YEAR 3 MONITORING REPORT

ROSES CREEK STREAM MITIGATION SITE

Burke County, North Carolina
NC DMS Project # 96309

RE: NCDEQ – Division of Mitigation Services
Roses Creek MY 3 Monitoring Report
DMS Project Number: 96309
Response to DMS Review Comments on Draft Year 3 Monitoring Report for Roses Creek

Figure 2.0 – 2.8. Current Condition Plan View

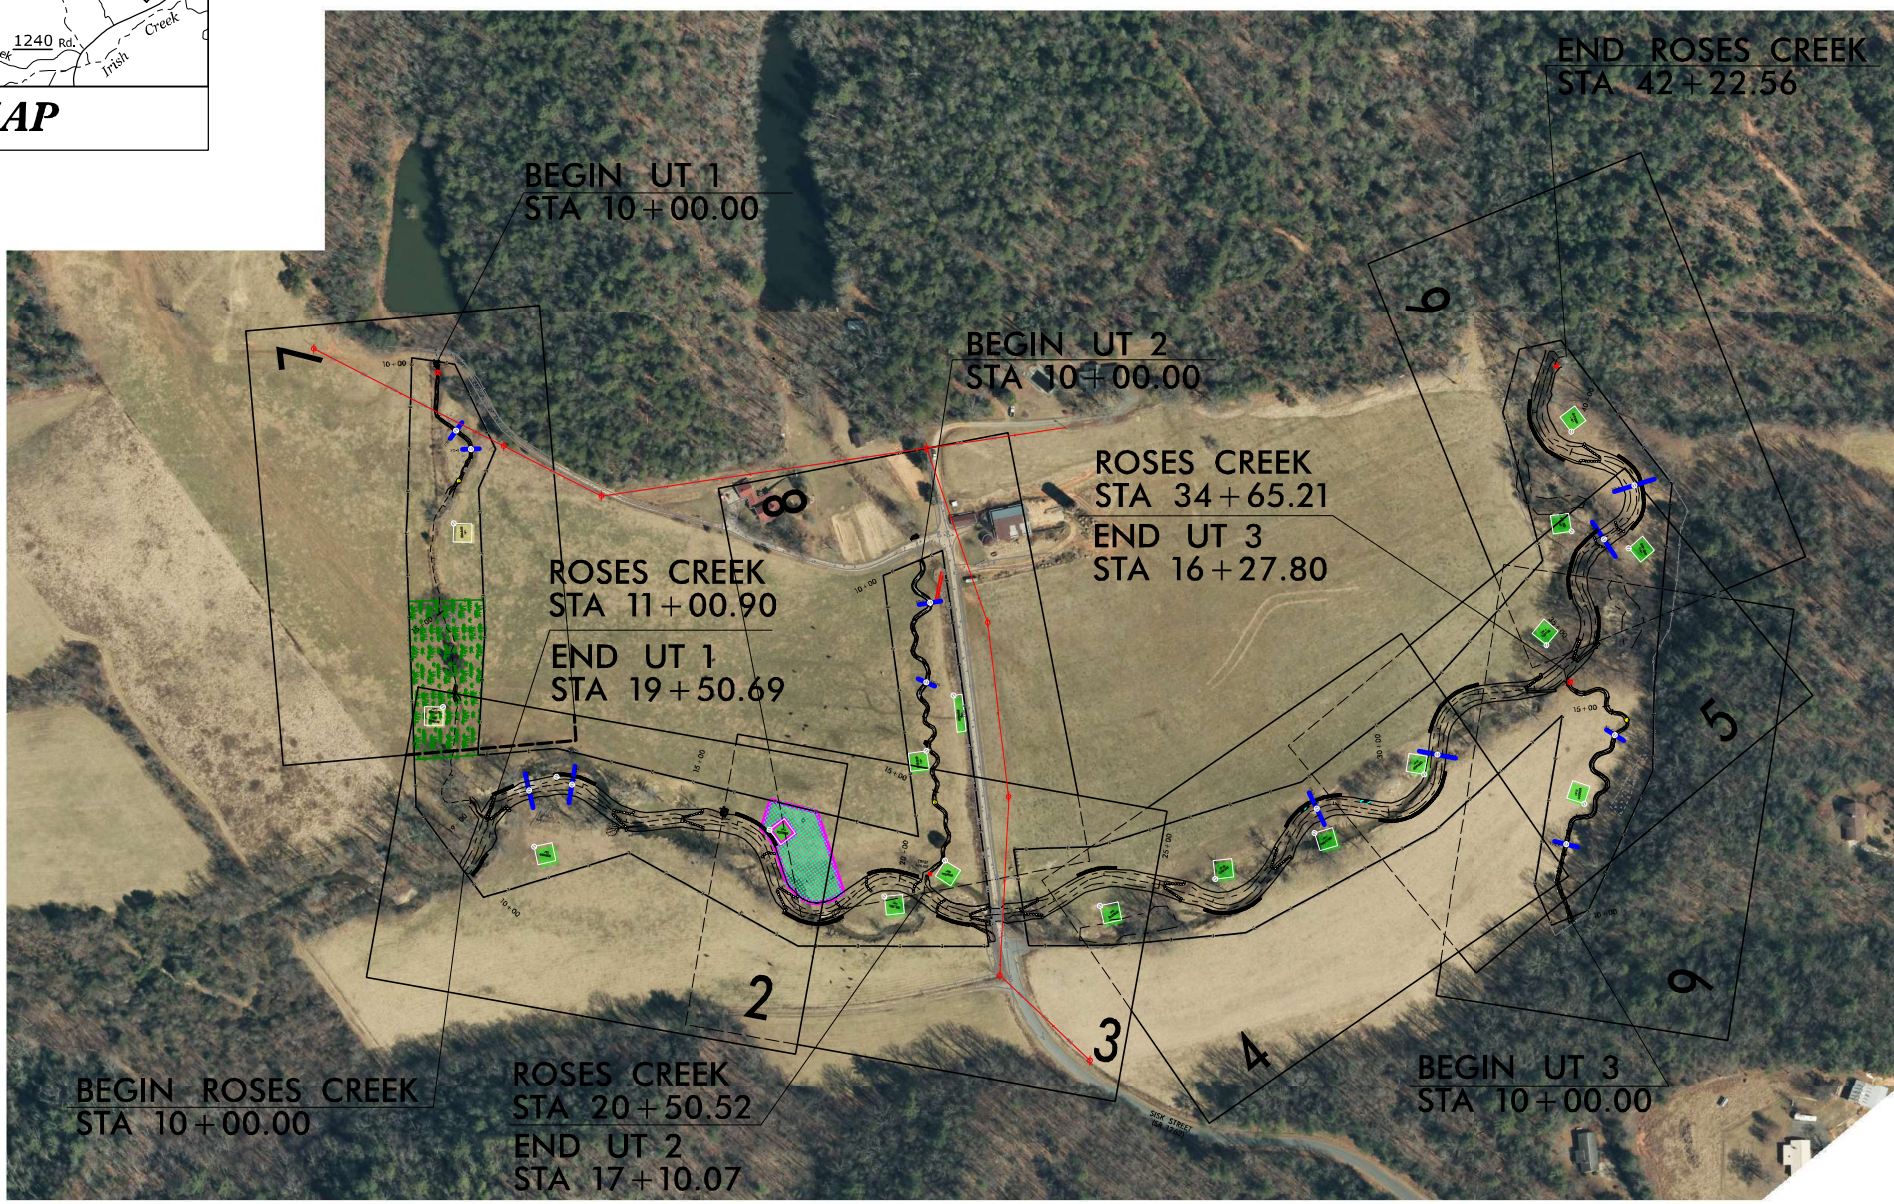
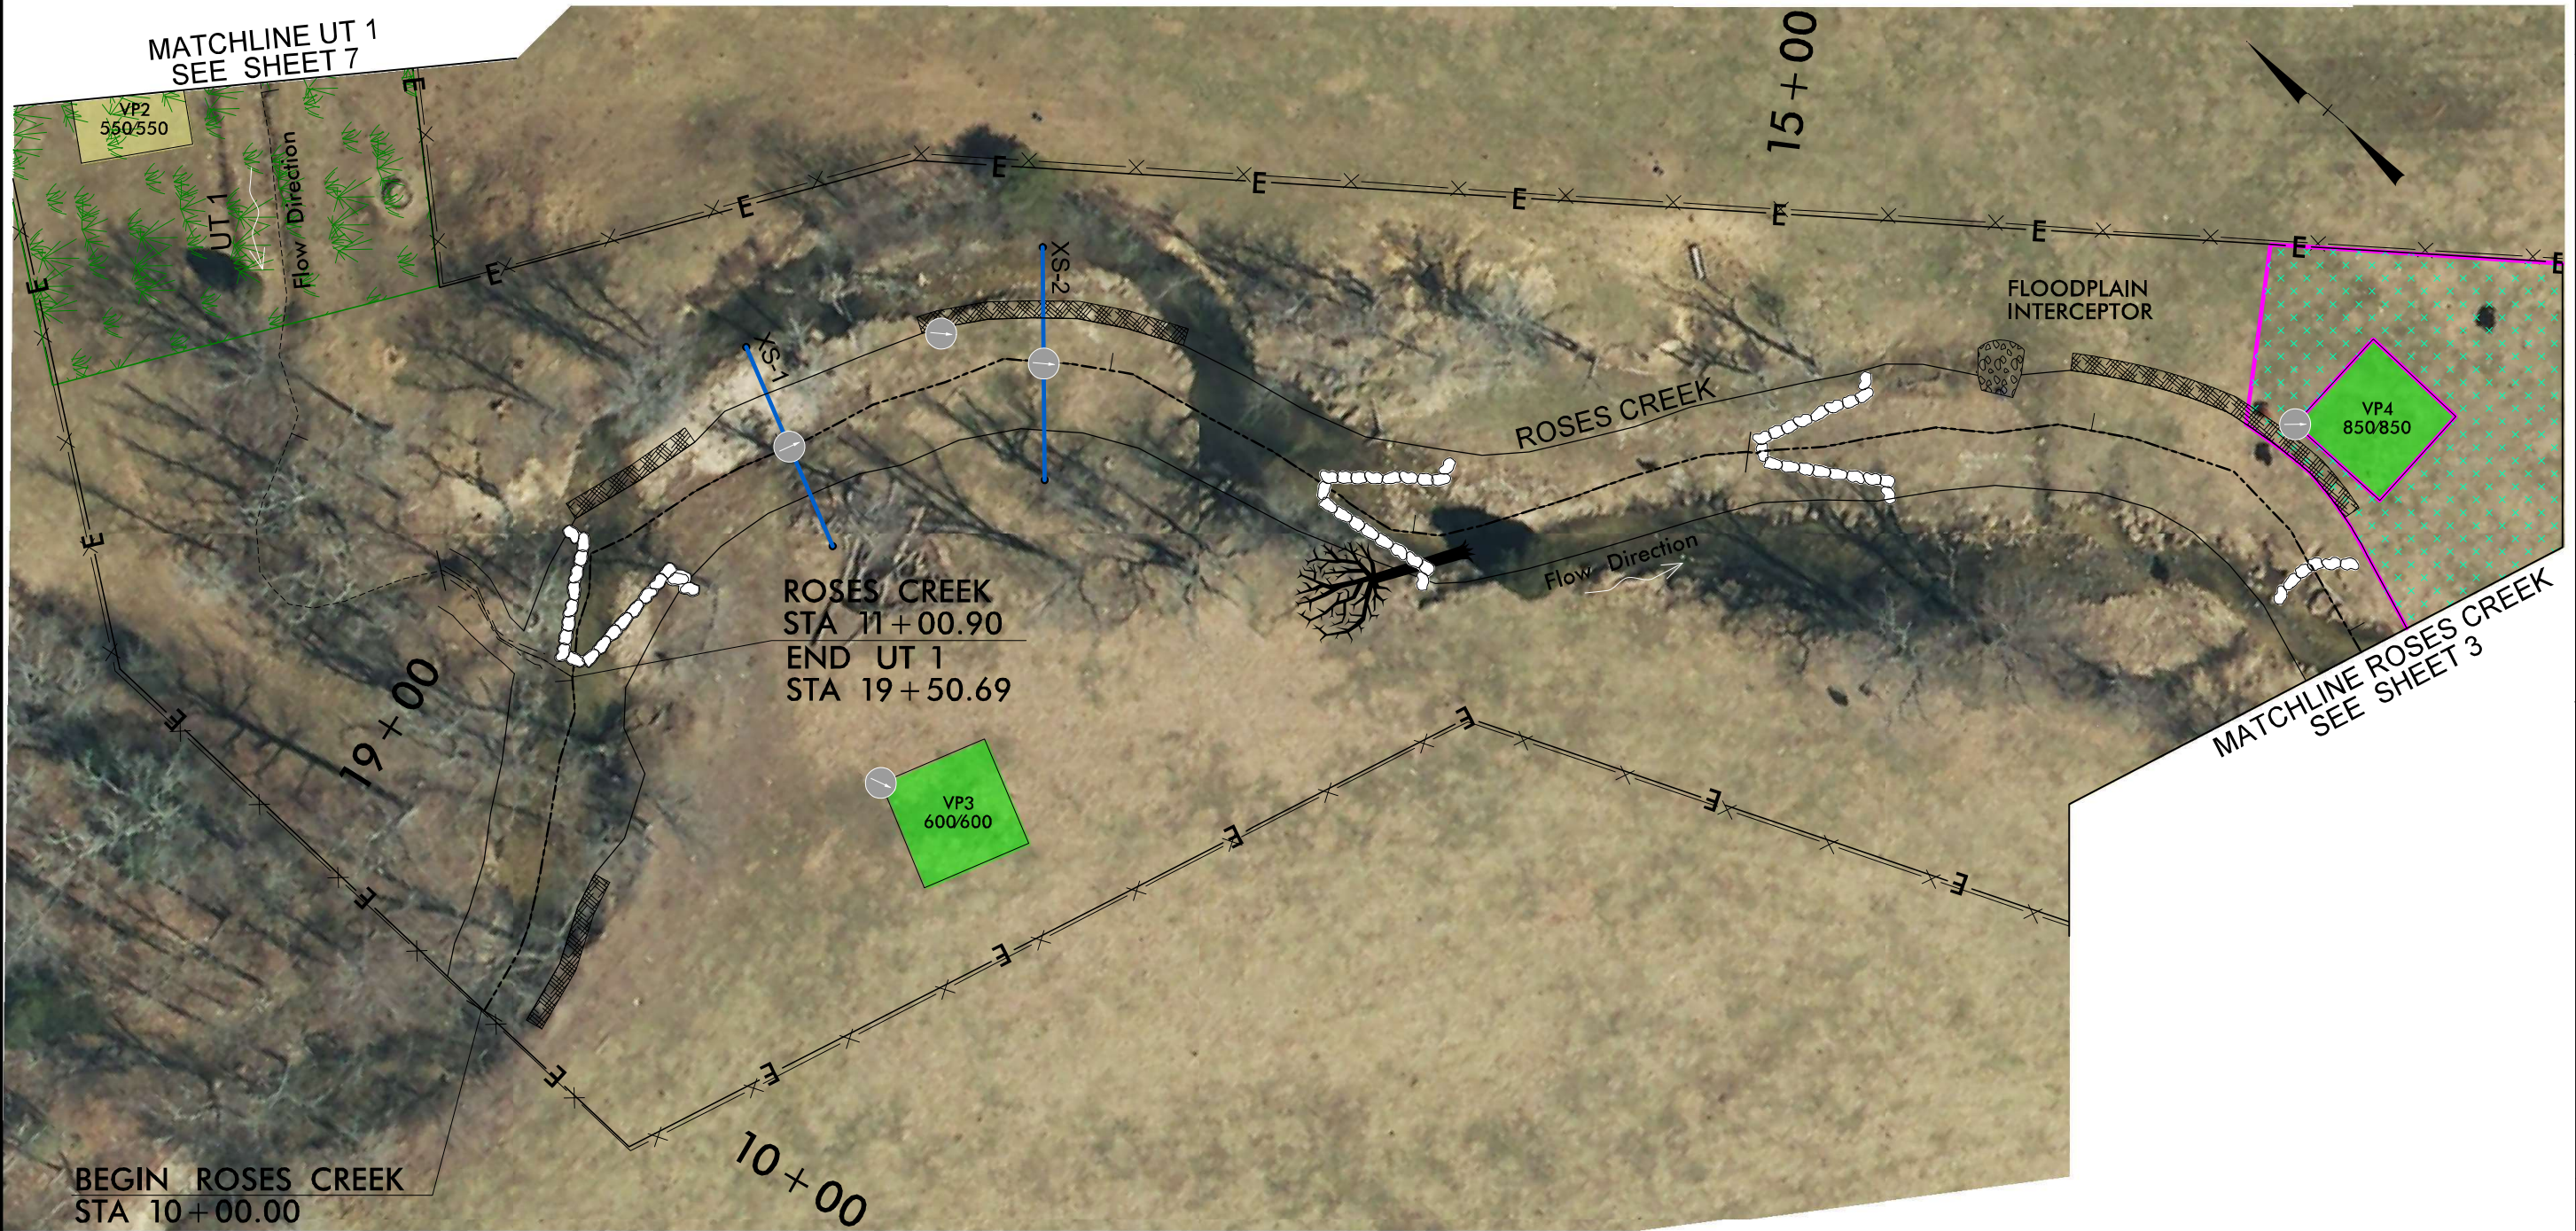
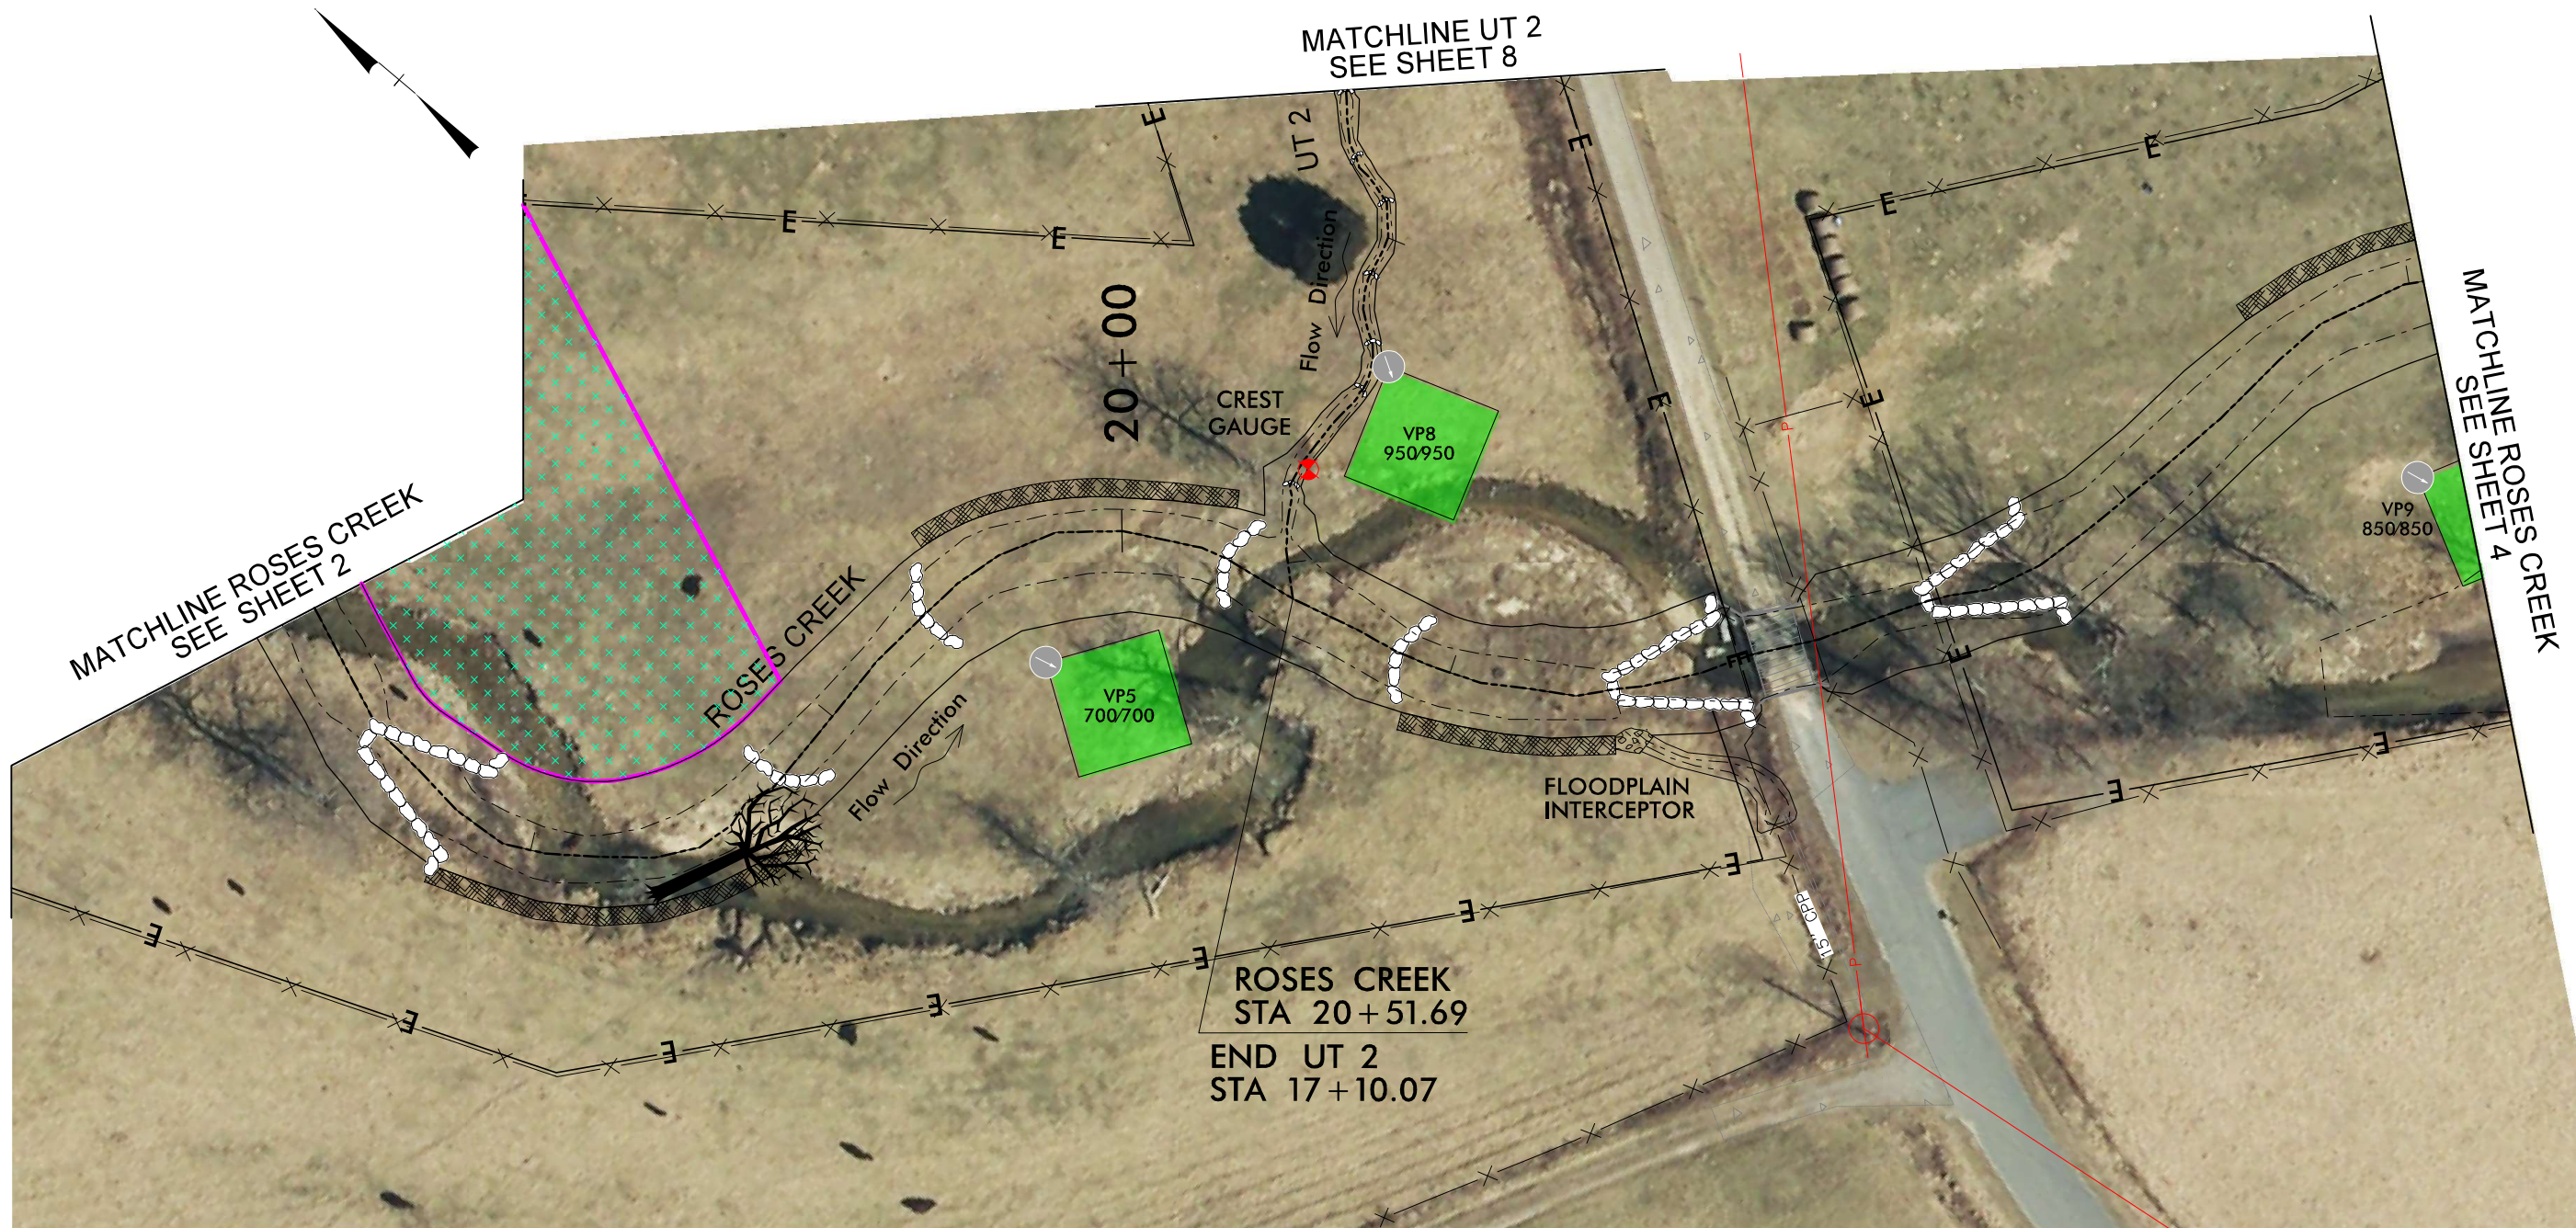
3. Please provide approximate locations of site issues / problem areas on the CCPVs; these were captured in 2017 but are not on the 2018 CCPVs. The mapped locations / areas presented in the narrative and tables should all be evident on the maps and mapped with as much detail as possible, including bare areas, silted reaches, erosion, invasive polygons, etc.

8. Update CCPV aerial, if available, to show restored stream alignment.

Response: The CCPV has been updated to show areas that are currently of concern. Many of the areas shown in 2017 were addressed during the repair work in October, 2018. A separate Adaptive Management Map has been included in the report in Appendix F. This figure shows areas that were repaired during 2018 and areas to be addressed in the near future.

Response: An updated aerial could not be located at this time.
